SI M 61 01 06
General Electrical Systems

Washer Fluid Leaks from Rear Washer Jet

R50 (Cooper) produced from 11/2003

R53 (Cooper S) produced from 11/2003

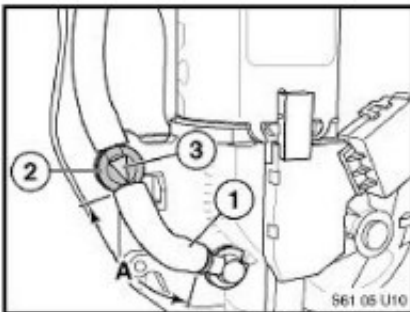
Vacuum created while the vehicle is in motion can cause washer fluid to leak from the rear washer jet.

In case of a customer complaint, install a non-return valve to the rear wiper motor.

1. Cut the washer fluid supply hose (1) approximately 25mm from the end. (dimension A)
2. Install check valve (2) with the arrow (3) pointing toward the rear hatch wiper motor.
